VERIFICATION REPORT FOR THE JARI/AMAPÁ REDD+ PROJECT

Project Title	<i>Jari/Amapá REDD+ Project</i>
Version	<i>1.0</i>
Report ID	<i>2016-9034</i>

Report Title	<i>Verification Report for the Jari/Amapá REDD+ Project</i>
Client	<i>Biofllica Investimentos Ambientais S.A.</i>
Pages	<i>57</i>
Date of Issue	<i>1 March 2016</i>
Prepared By	<i>Det Norske Veritas (USA) Inc</i>
Contact	<i>155 Grand Avenue, Suite 500, Oakland, CA 94612 Tel: +1 510 891 0446 Fax: +1 510 891 0440</i>
Approved By	<i>Thomas Andresen Gosselin</i>
Work Carried Out By	<i>Lead Auditor: Kyle Holland</i>

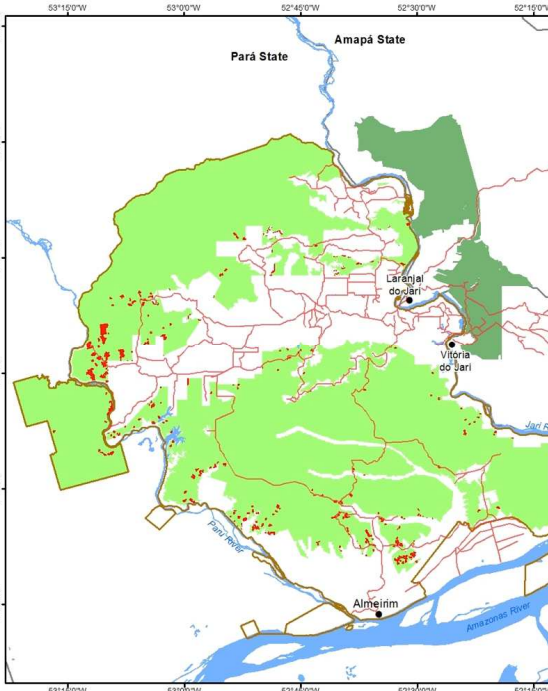
<p>5 CAR 5 Document Reference: Project Description – 12 April 2013, Section 1.1, 3.4 and 5.1 Standard Reference: AFOLU Requirements 3.4, Section 3.6.4, 4.6.16 VM0016, Part 1, Section 1.3</p> <p>Market leakage assessments shall occur at validation and verification.</p> <p>Where the project baseline includes illegal logging activities that supply regional, national and/or global timber markets, domestic market leakage shall be quantified using the market leakage discount factors for IFM projects set out in Sections 4.6.13 and 4.6.14. The market</p>	<p>Accounting for Market Effects is not applicable in the case of Jari/Amapá REDD+ Project. The project baseline does not include illegal logging that supply regional, national and/or global timber market.</p> <p>Along all Project Description (VCS), with emphasis on Section 1.1 (Summary: “<i>Despite the social and environmental importance of the Vale do Jari, this region is threatened by agricultural and cattle activities and human settlements as well as large infrastructure projects.</i>”) and section 2.4 Baseline Scenario (Step 3 of VM0015) the project proponent attributed 100% of deforestation to squatters (main agent) coming from other parts of Brazil (migration is one of the drivers) and clear cutting the forest as a mean to establish “tenure” and to develop small scale agriculture and pastures for their subsistence. In this section is also explained that the main underlining causes are public policies on infrastructure and colonization. Which means that illegal logging (with commercial proposes) has a minor or inexistent role in the baseline scenario</p> <p>Besides, as mentioned in section 3.4 of project Description, Amapá Sate doesn’t have a logging industry well developed, even when compared with other Amazon states, and the wood extracted from Amapá represents 1% of harvested wood in the</p>	<p>DNV GL Assessment 1 October 2015</p> <p>Based on field observations and interviews during the site visit, illegal logging appears only to supply familial requirements and does not contribute to any regional, national or global markets. Therefore, this finding is closed.</p>
